**NEW YORK STATE THRUWAY AUTHORITY  
DEPARTMENT OF ENGINEERING**

**AMENDMENT NO. 2  
TO**

**CONTRACT TANY 26-17B  
D215020  
REPLACEMENT OF THE PINE HILL ROAD  
BRIDGE OVER I-87 AT MP 47.58,  
REHABILITATION OF I-87 BRIDGE OVER  
SMITH CLOVE ROAD AT MP 47.04,  
AND RESURFACING AND SAFETY IMPROVEMENTS  
ON I-87 BETWEEN MP 46 AND MP 48  
IN THE NEW YORK DIVISION  
OF THE NEW YORK STATE THRUWAY  
IN ORANGE COUNTY**

**IN THE LETTING OF  
JUNE 17, 2026**

DRAWING NUMBER: BTCP-1

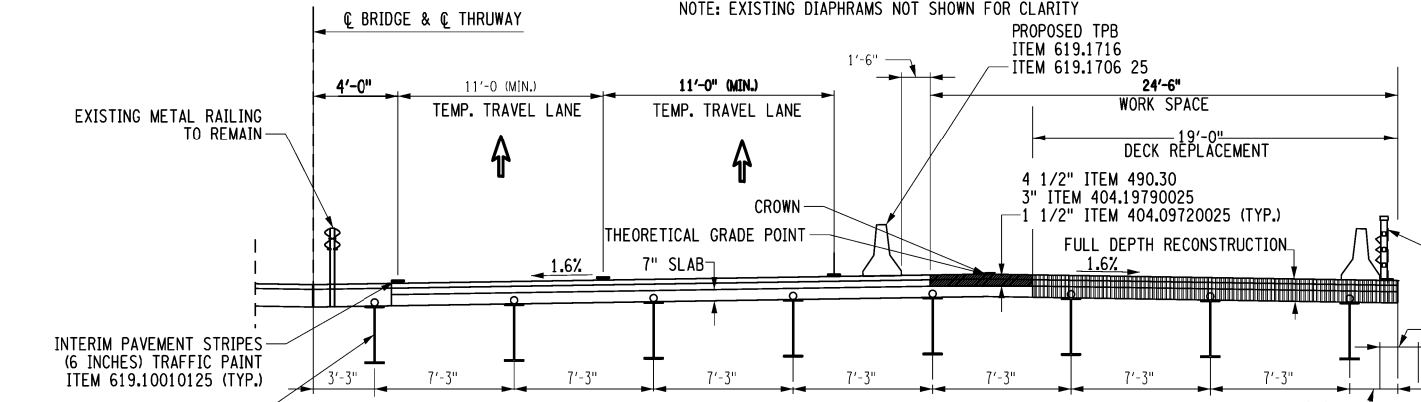
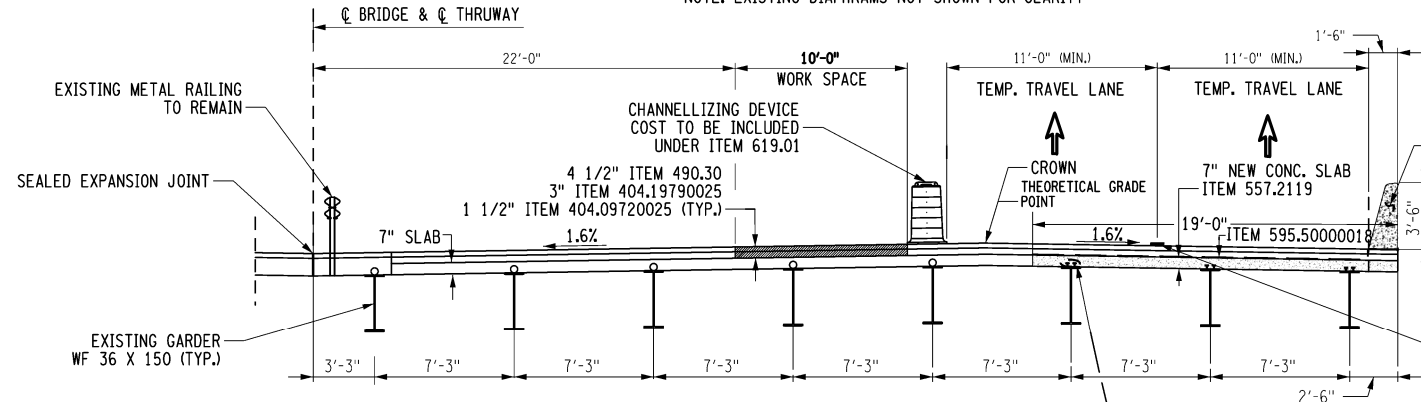
7. **DELETE** Drawing Number BTCP-1, Sheet 113 of 180, and **SUBSTITUTE** with the attached Drawing Number BTCP-1, Sheet 113A2 of 180. In the Stage 2 (Northbound) Typical Half Section, the cold milling (4 ½" of Item 490.30) and resurfacing (3" Item 404.19790025 and 1 ½" Item 404.09720025) have been moved to outside of the 19'-0" deck overhang replacement. The details have been changed to consistently show how the asphalt over the deck overhangs is being paid for (under Item 202.2201). The decrease in Miscellaneous Cold Milling as mentioned in Entry 2 above is due to no longer including removal of the asphalt overlay in the deck overhang areas.

TITLE OF PROJECT I-87 BRIDGE REHABILITATION OVER SMITH CLOVE ROAD (MP 47.04)	CONTRACT NUMBER: TANY 26-17B
LOCATION OF PROJECT VILLAGE OF WOODBURY ORANGE COUNTY BIN 5514279	DATE: 05/21/2025
TITLE OF DRAWING BRIDGE APPROACH/ WITH SHLDR RECONSTRUCTION	DRAWING NUMBER: APPR-1

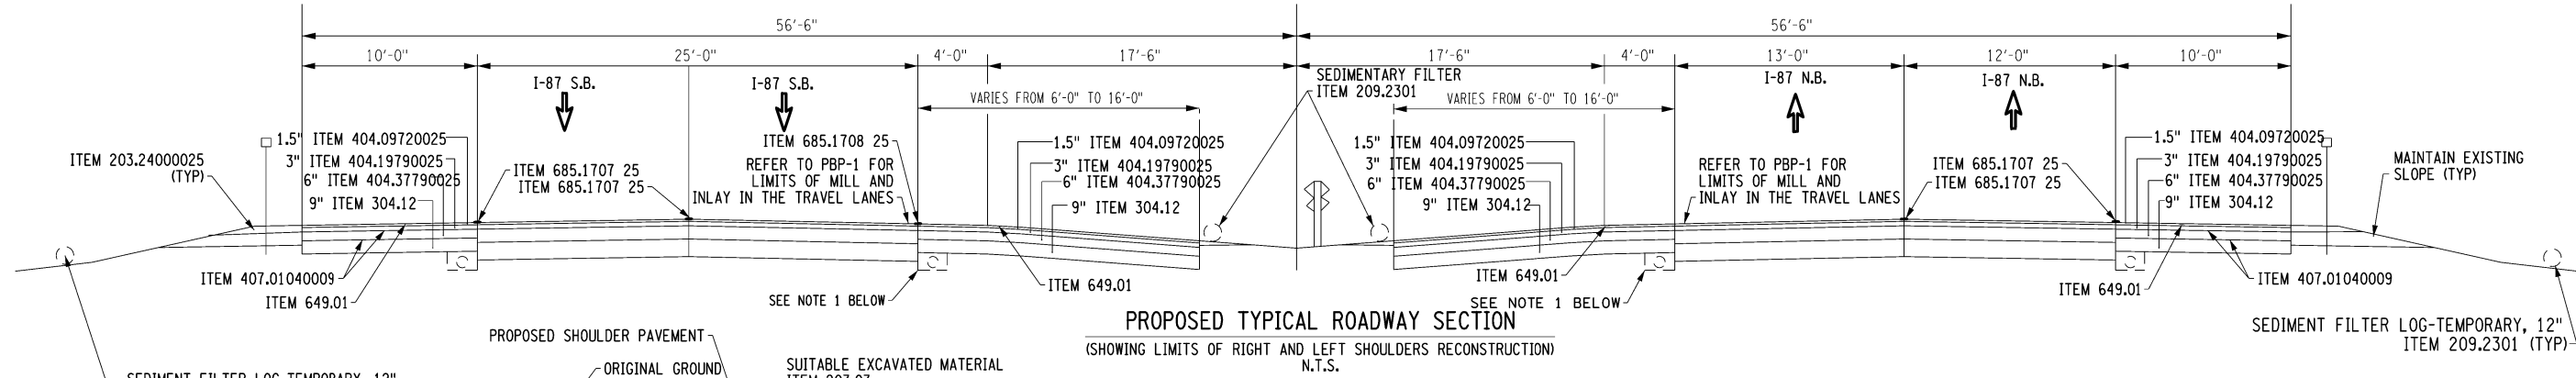
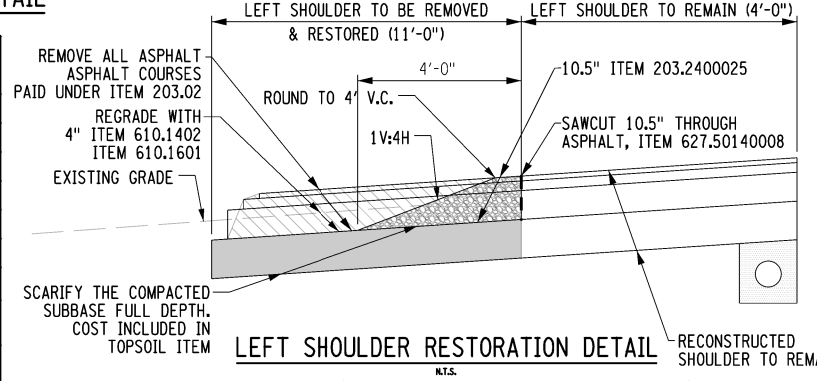
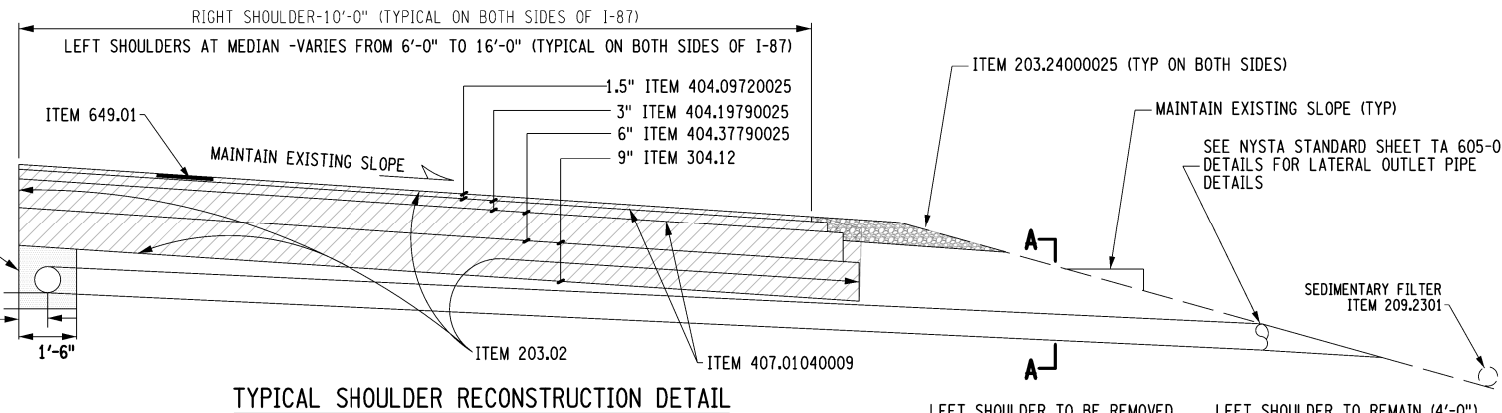
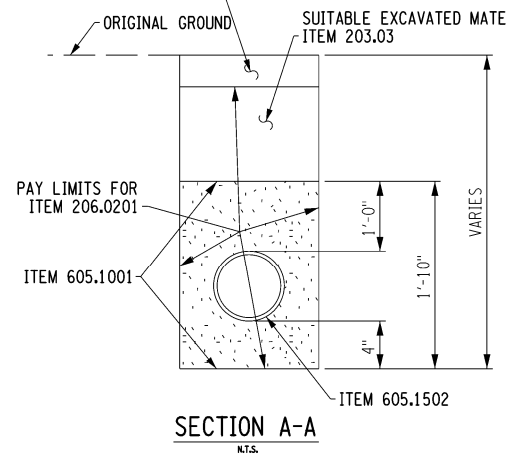
8. **DELETE** Drawing Number APPR-1, Sheet 114 of 180, and **SUBSTITUTE** with the attached Drawing Number APPR-1, Sheet 114A2 of 180. The Section A-A detail has been corrected. Previous callouts to soil and seed have been changed to asphalt pavement. Dimensions have been revised and a new item for the underdrain is now shown. In The Typical Shoulder Reconstruction Detail, a new call out for the outlet pipe has been added. In the Left Shoulder Restoration Detail, the width and depth of the shoulder backup have been increased, and the required slope updated. Note 1 has been updated to now account for the changes being proposed in this Amendment. Lastly, in the list of Items Table, Existing Roadway Section, Proposed Typical Roadway Section, and Typical Shoulder Reconstruction Detail, the prospective bidder is to revise any previous reference in the drawing for Item 209.2301, Sediment Filter Log Temporary, 12" to read as Item 209.1311, Sediment Filter Log - Temporary, 12", Type A, instead.

TITLE OF PROJECT I-87 BRIDGE REHABILITATION OVER SMITH CLOVE ROAD (MP 47.04)	CONTRACT NUMBER: TANY 26-17B
LOCATION OF PROJECT VILLAGE OF WOODBURY ORANGE COUNTY BIN 5514279	DATE: 05/21/2025
TITLE OF DRAWING I-87 WORK ZONE TRAFFIC CONTROL PLAN STAGE 1 (6 OF 7)	DRAWING NUMBER: WZTC-1-06

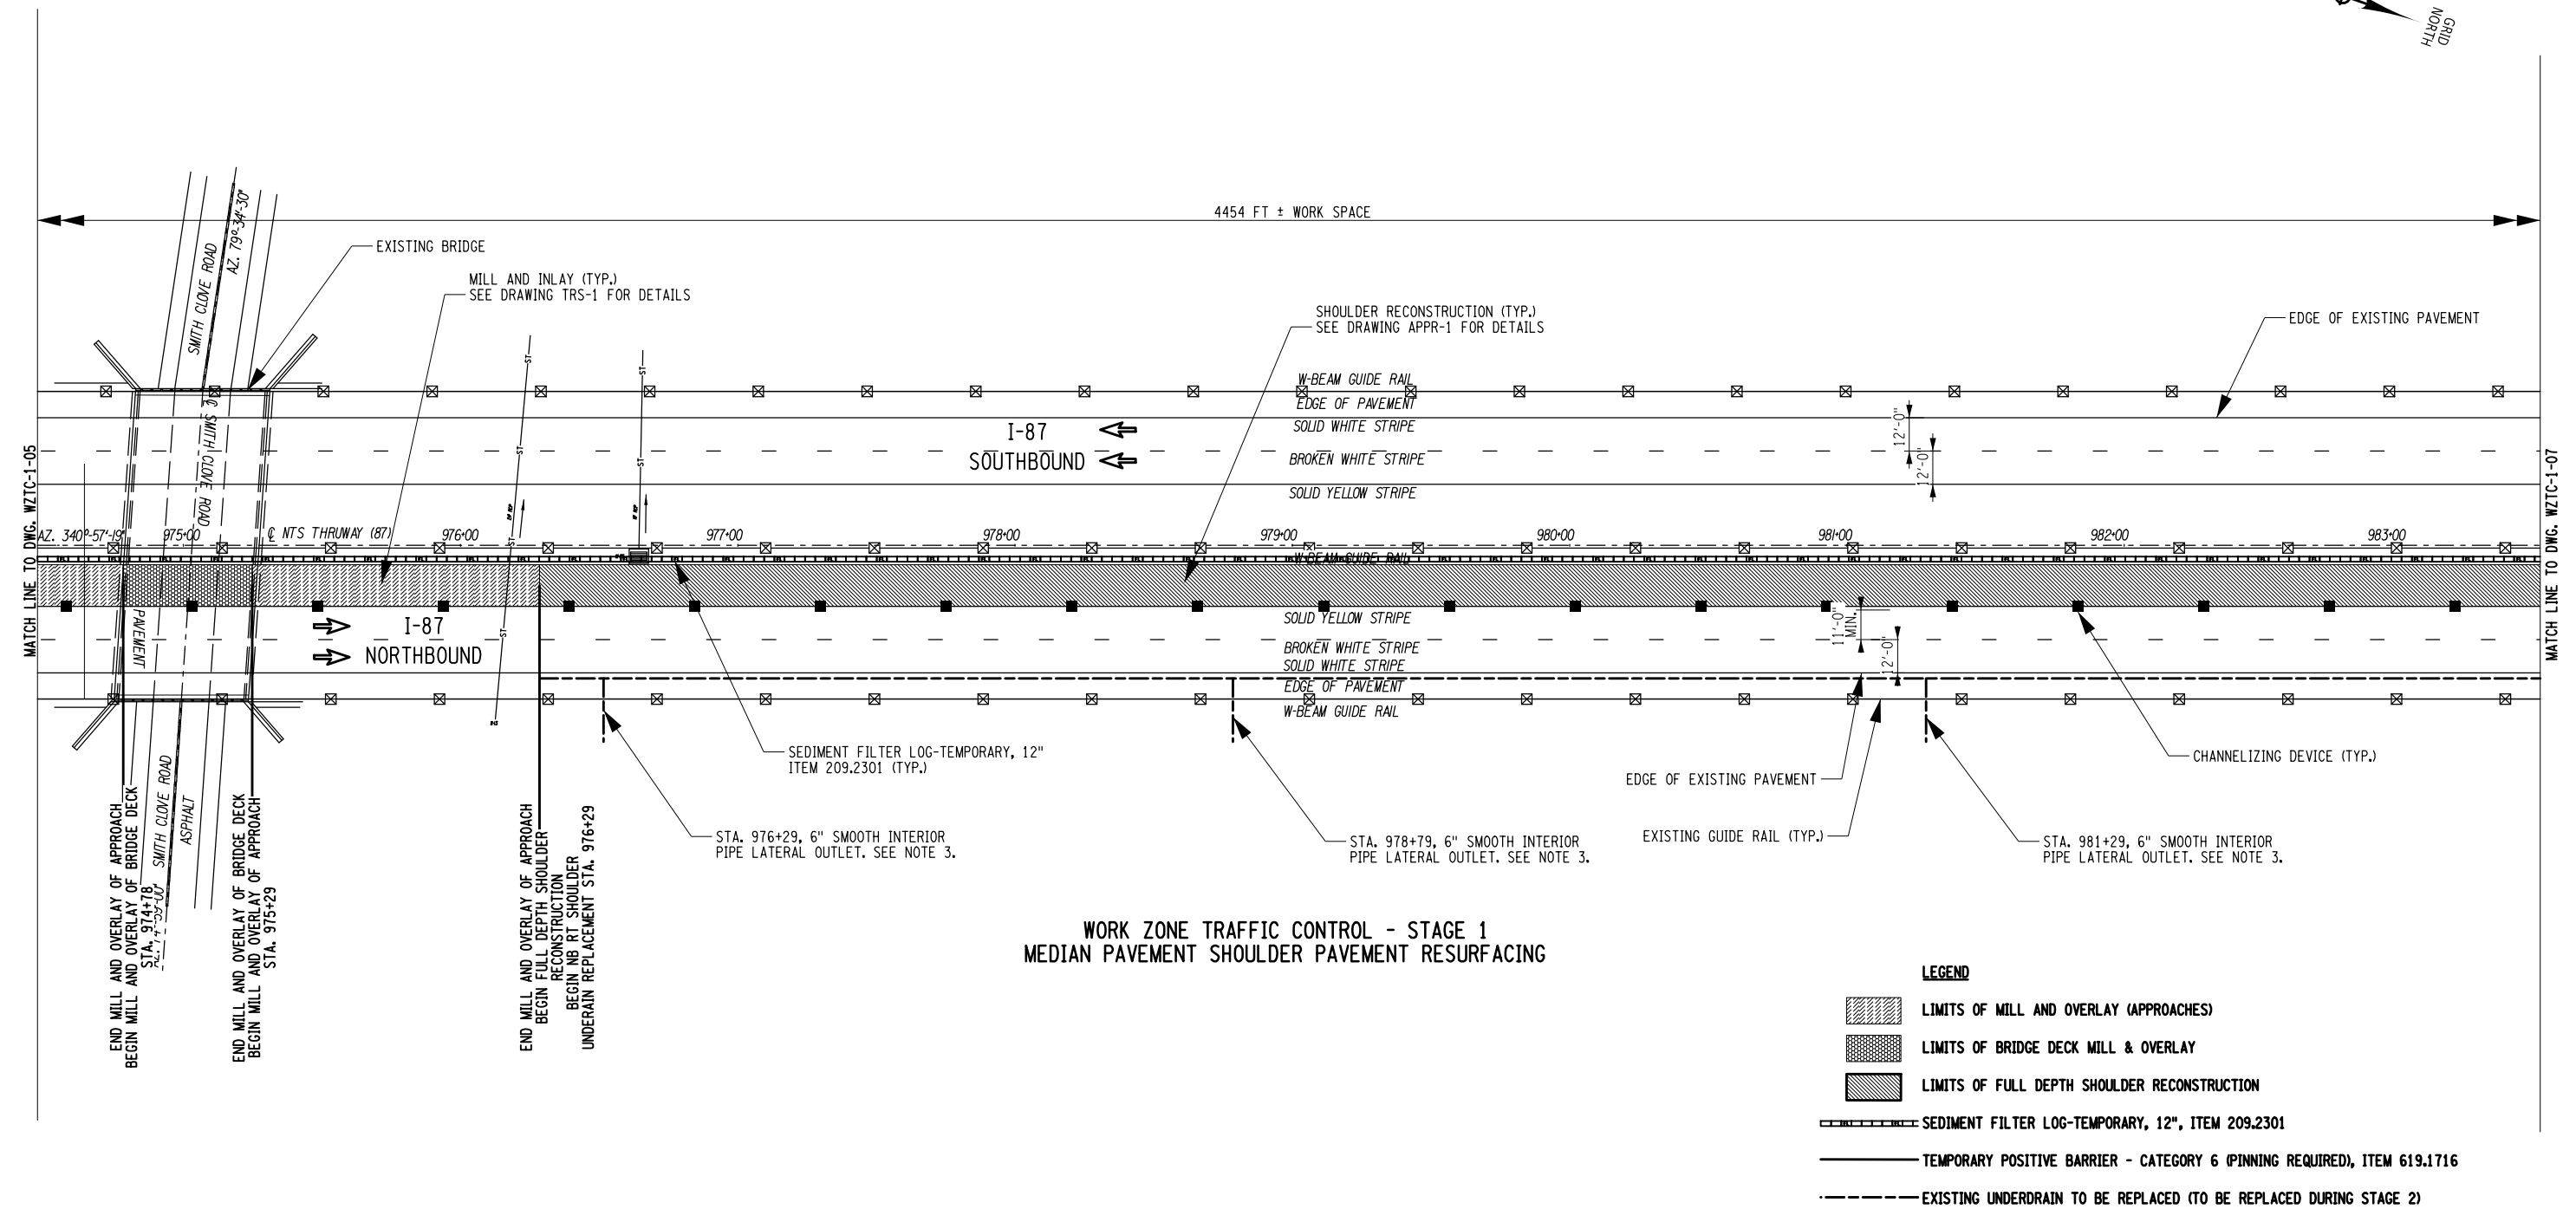
14. **DELETE** Drawing Number WZTC-1-06, Sheet 122 of 180, and **SUBSTITUTE** with the attached Drawing Number WZTC-1-06, Sheet 122A2 of 180. Three new station references for the proposed 6" Smooth Interior Pipe Lateral outlets have been added. A new Note 3 has been added to refer to the outlet details. A new Legend has been added to account for the proposed underdrain to be replaced

during Stage 2. Lastly, in the Legend and as called out near Station 977+00 (middle left), the prospective bidder is to revise any previous reference in the drawing for Item 209.2301, Sediment Filter Log Temporary, 12" to read as Item 209.1311, Sediment Filter Log - Temporary, 12", Type A, instead.

CONTRACT NUMBER: TANY 26-17B  
DATE: 05/21/2025  
DRAWING NUMBER: WZTC-1-07

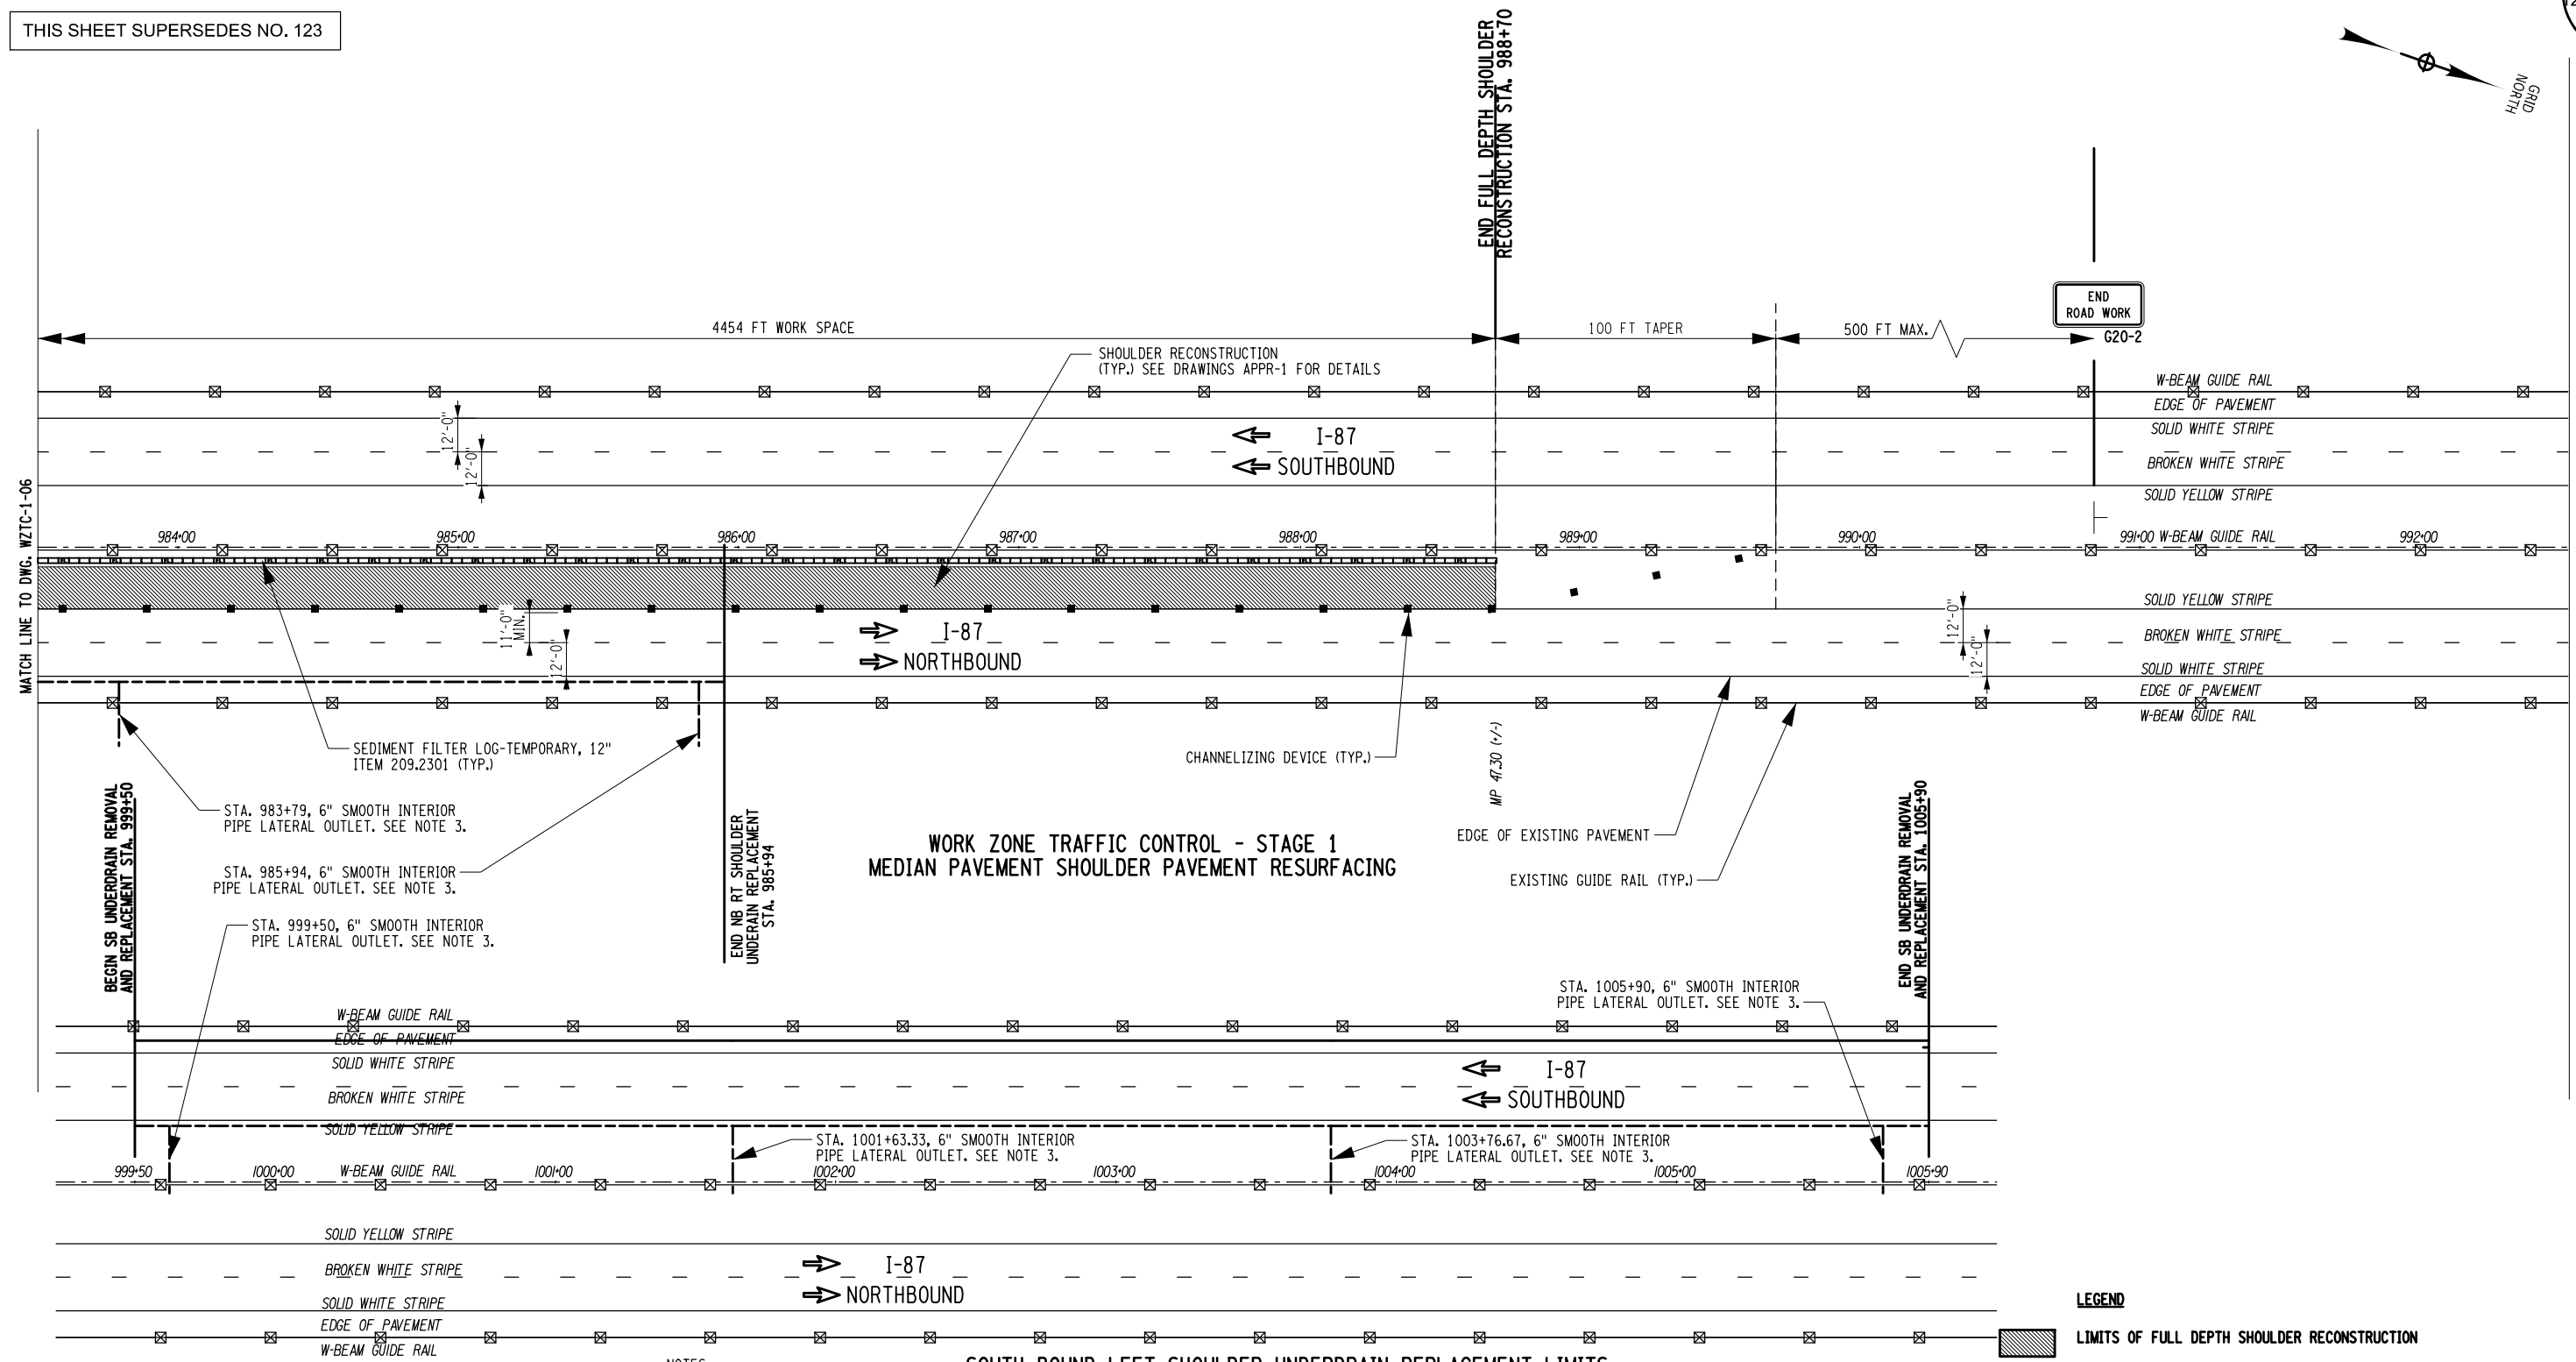
15. **DELETE** Drawing Number WZTC-1-07, Sheet 123 of 180, and **SUBSTITUTE** with the attached Drawing Number WZTC-1-07, Sheet 123A2 of 180. Southbound Left Shoulder Underdrain Replacement Limits have been added to the bottom half of the drawing. Six new station references for the proposed 6" Smooth Interior Pipe Lateral outlets have been added to the drawing. A new Note 3 has been added to refer to the outlet details. A new Legend has been added to account for the proposed underdrain to be replaced during Stage 2 (NB) and Stage 5 (SB). Lastly, in the Legend and as called out near Station 984+00 (bottom left), the prospective bidder is to revise any previous reference in the drawing for Item 209.2301, Sediment Filter Log Temporary, 12" to read as Item 209.1311, Sediment Filter Log - Temporary, 12", Type A, instead.
